## Board of Zoning Appeals

**SBVA-1125-000004 11446 Alpharetta Highway**

**Subject:** SBVA-1125-000004, 11446 Alpharetta Hwy

Re: Genesis Renovation, 150' Stream Buffer Variance.

## ALTERNATIVE SITE PLAN

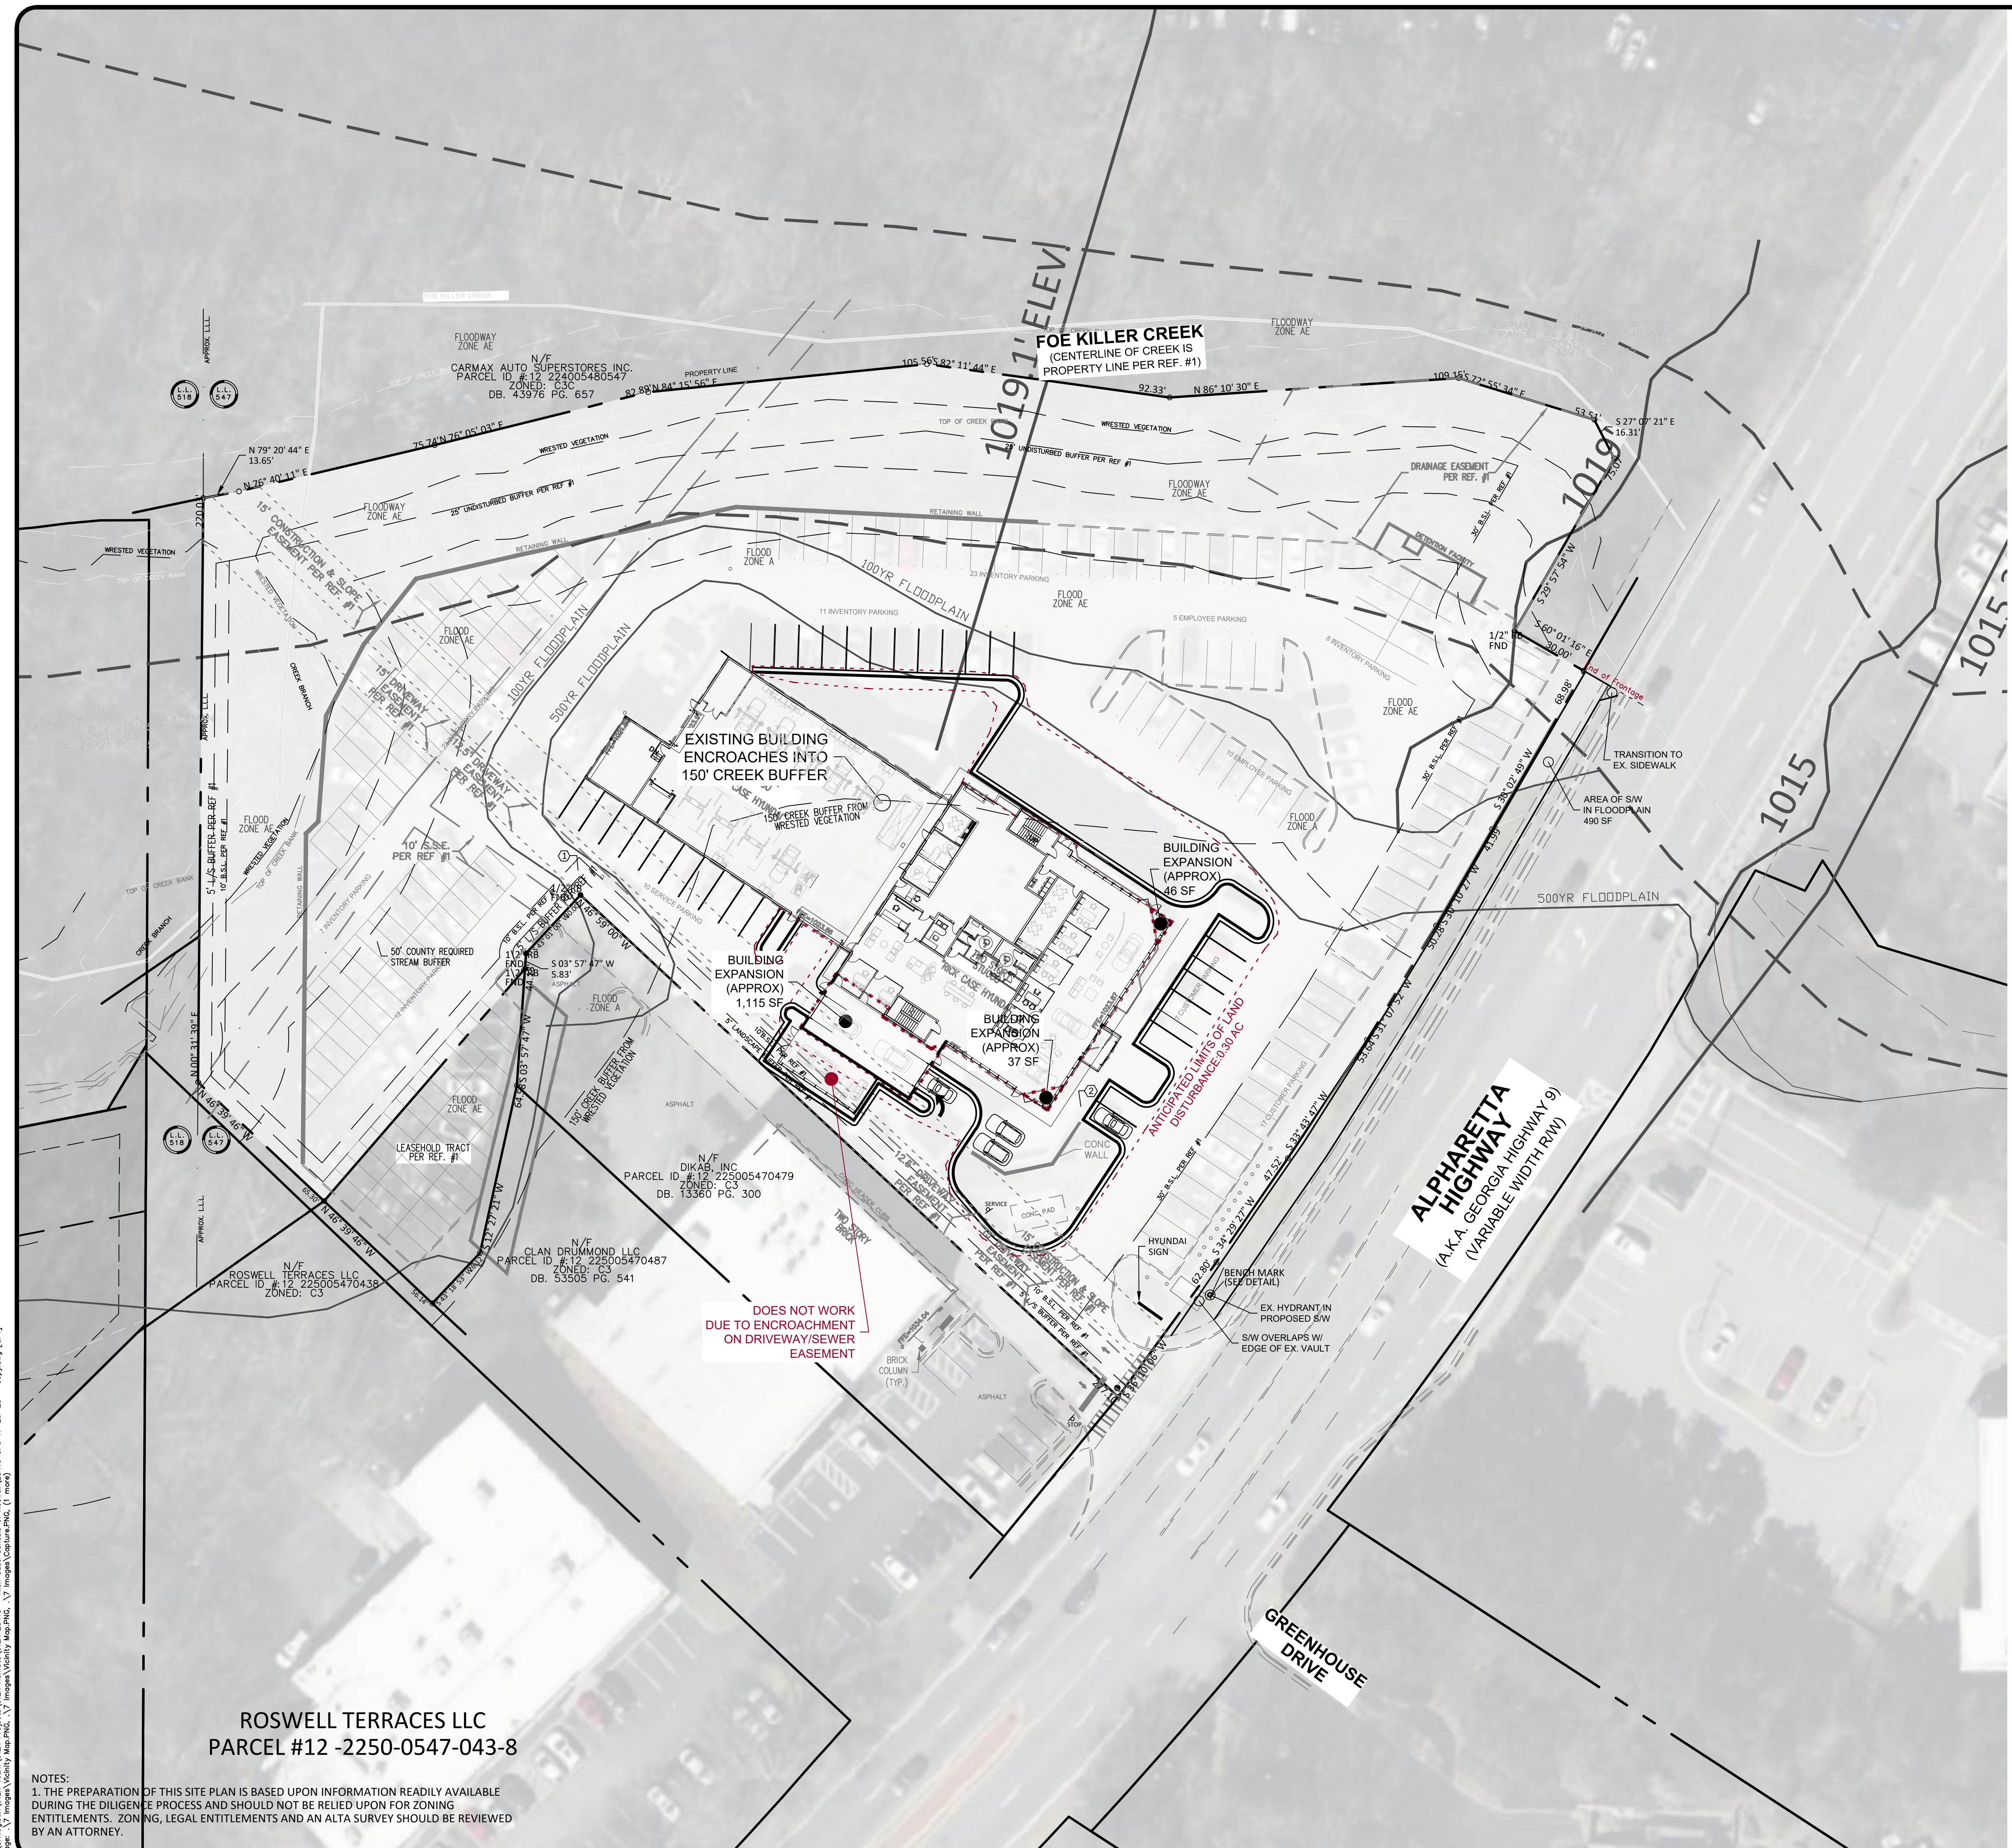
**c. Whether alternative designs are possible which require less intrusion or no intrusion.**

The applicant has coordinated with City staff ahead of submitting the application for a variance request. During that coordination, staff provided information about the stream buffers, the impervious setback, and the city's stormwater requirements. The applicant also developed an alternative plan that avoids intrusion into the impervious setback; however, this option would require relocating the building expansion to the south side of the existing structure. This

relocation is not feasible due to encroachment on the driveway access easement shared with the adjacent property.

RICK CASE GENESIS OF ROSWELL

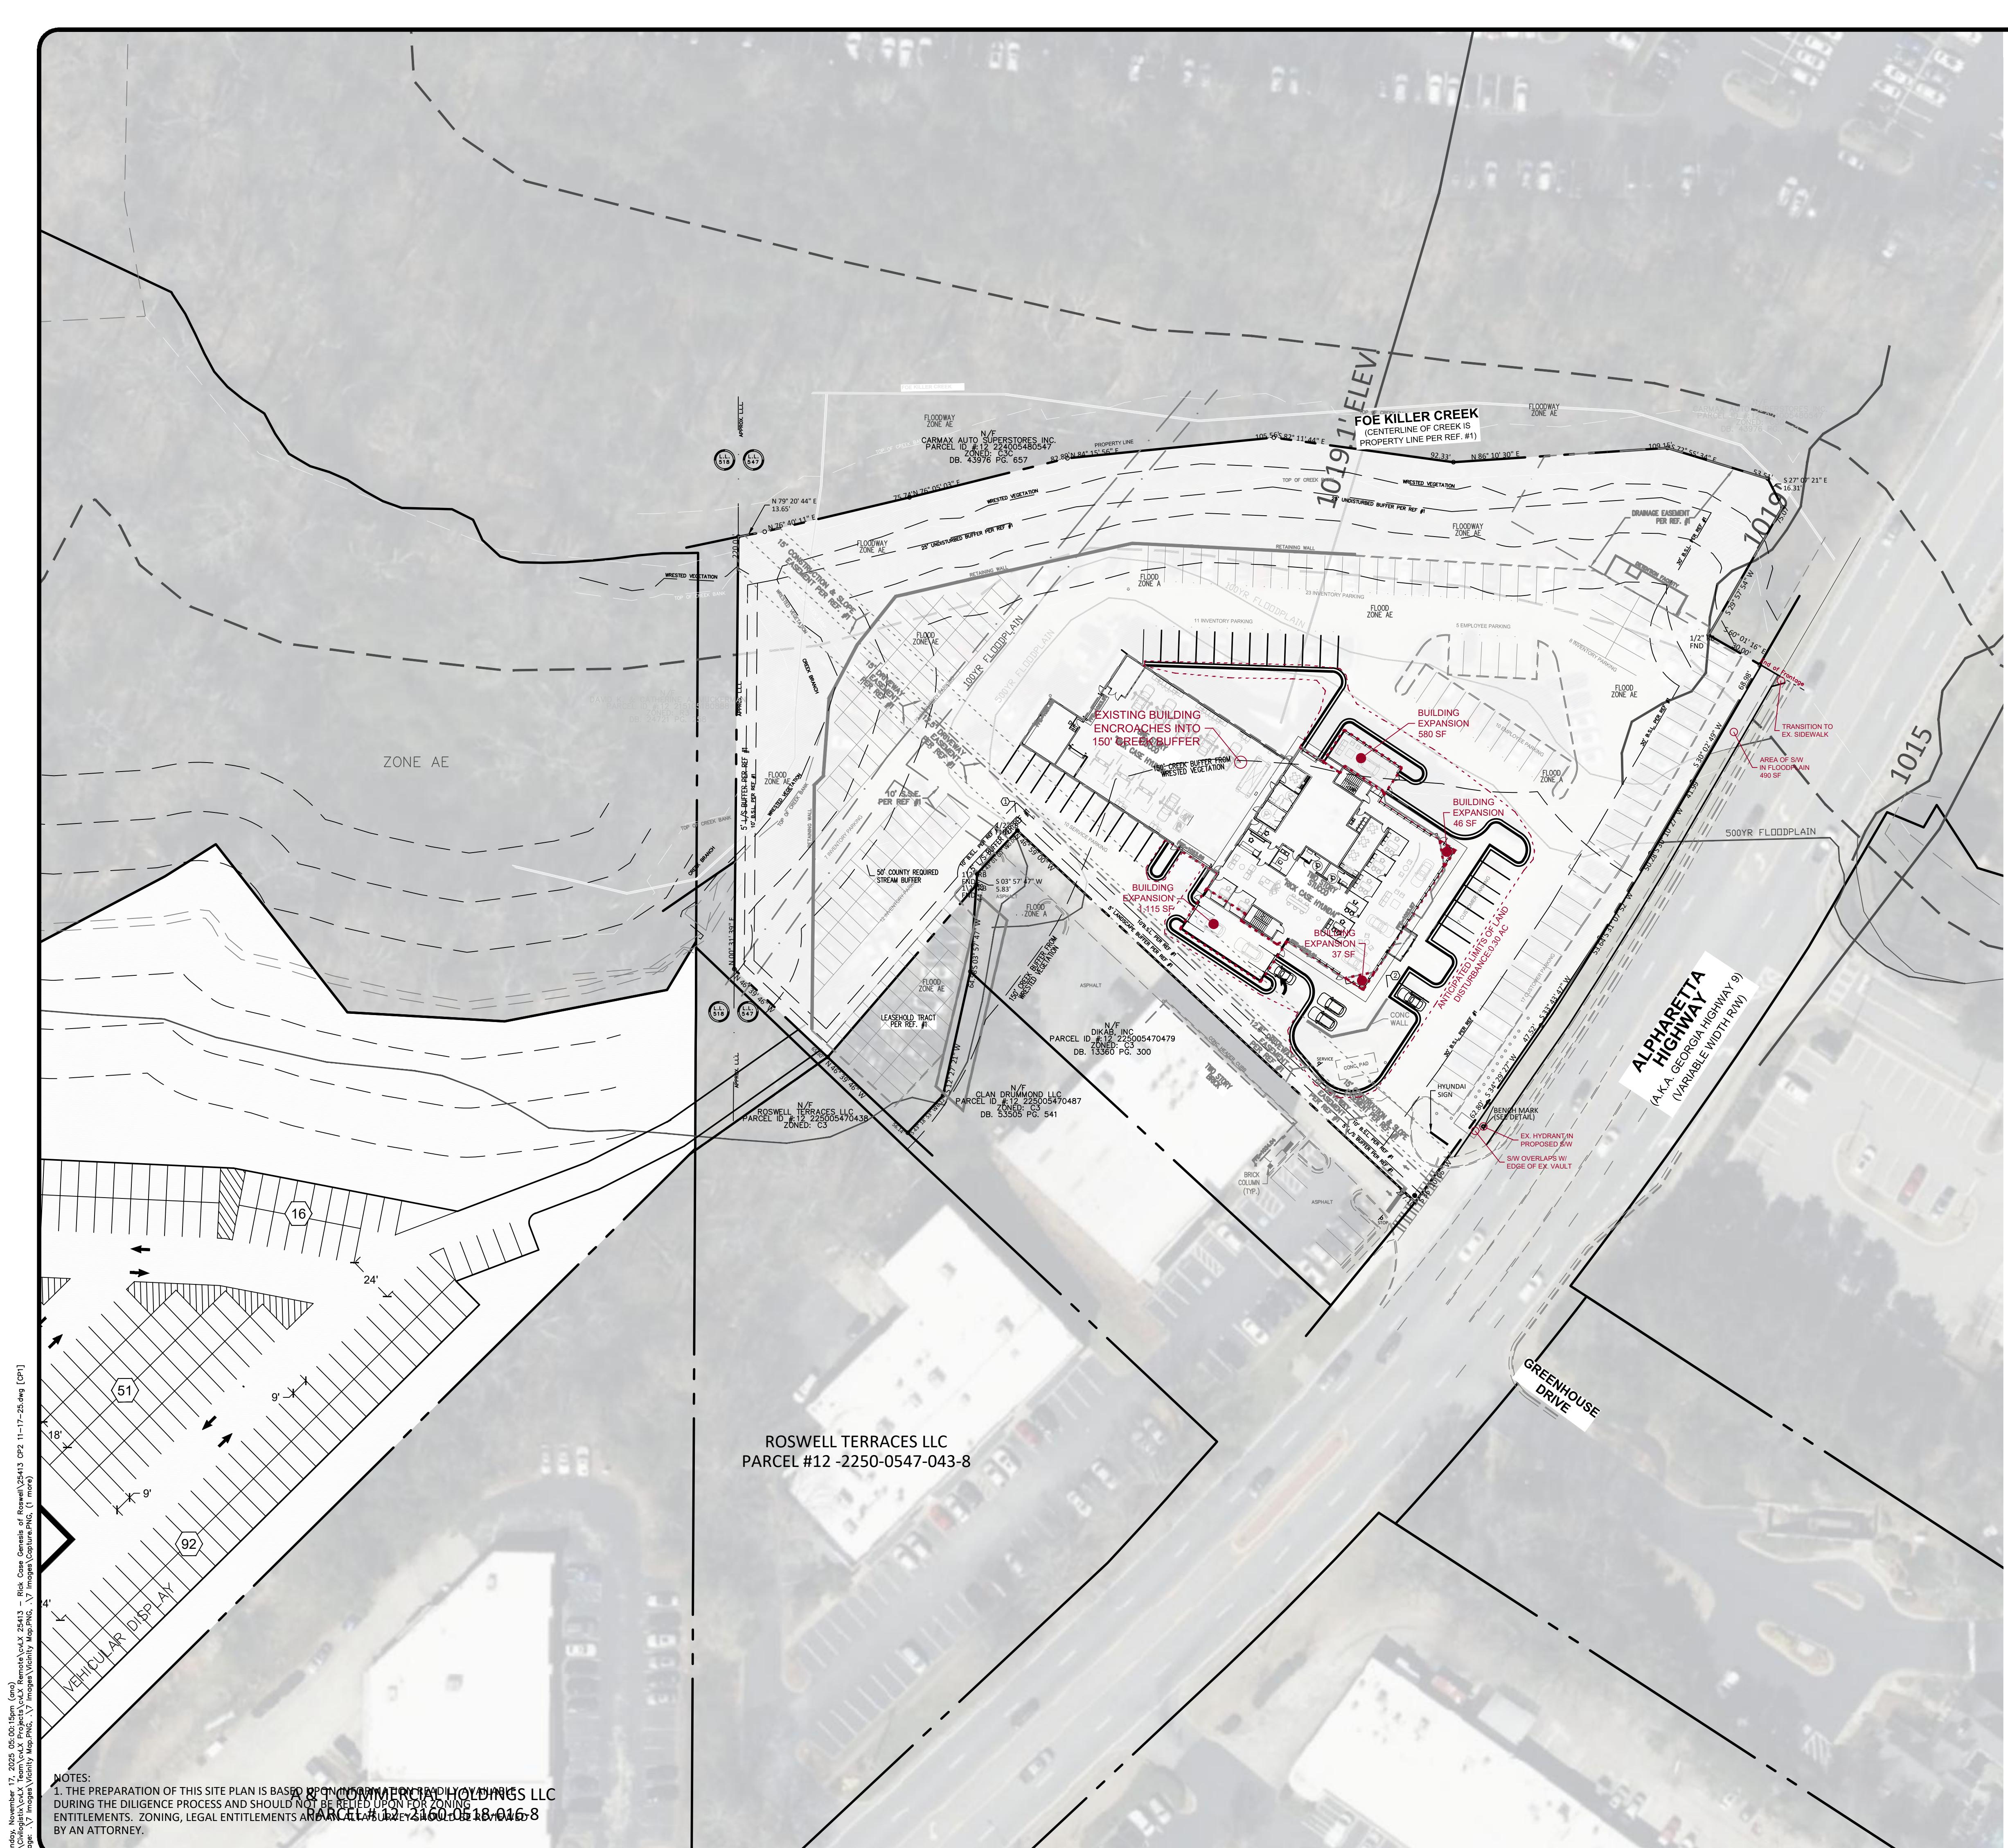
ITEM REVIEW NAME (DEPARTMENT)	ASSIGNED TO	DU	COMPLETE	STATUS
Engineering (Engineering)	Osmany Ordonez	01/15/2026	01/14/2026	Requires Re-submit
Corrections	General (Not Resolved) - 1. In all plans show/label the 100-ft undisturbed City buffer. It's important to show that the proposed improvements do not encroach this buffer. 2. Provide existing conditions survey. In the existing conditions, provide a table that indicates the total amount (square feet) of intrusion into the buffers before the proposed improvements. 3. What happened with the Alternate plan that shows the proposed improvements outside the buffers? I thought I saw one at some point. Explain why the alternate plan is not feasible. 4. See markups on drawings.			
P&Z Variance (Planning & Zoning)	Richard Sykes	01/15/2026	01/14/2026	Approved
Comments	Planning and Zoning does not have any comments for this Stream Buffer Variance.			
Stormwater (Stormwater)	Coleman Cleveland	01/15/2026	01/15/2026	Requires Re-submit

1. THE PROPERTY WILL REQUIRE A VARIANCE TO EXPAND THE EXISTING BUILDING INTO THE STREAM BUFFER DESPITE THE FACT THAT IMPERVIOUS AREA ALREADY EXISTS IN THAT LOCATION. THE EXISTING BUILDING IS NON-CONFORMING WITH RESPECT TO THE BUFFER.
2. THE EXISTING BUILDING IS OUTSIDE (AND 4.76' ABOVE) THE EXISTING FLOODPLAIN (ELEV: 1019.1'). NO FLOODPLAIN VARIANCES ARE ANTICIPATED WITH RESPECT TO THE BUILDING EXPANSION.
3. A RUNOFF REDUCTION WAIVER WILL BE NEEDED SINCE THERE IS NO VIRGIN, NON-COMPACTED SOILS UNDER THE EXISTING BUILDING/PAVEMENT.
4. 490 SF OF R/W SIDEWALK WILL BE RELOCATED WITHIN THE FLOODPLAIN. A R/W DEDICATION OF UP TO 6" WILL BE REQUIRED.
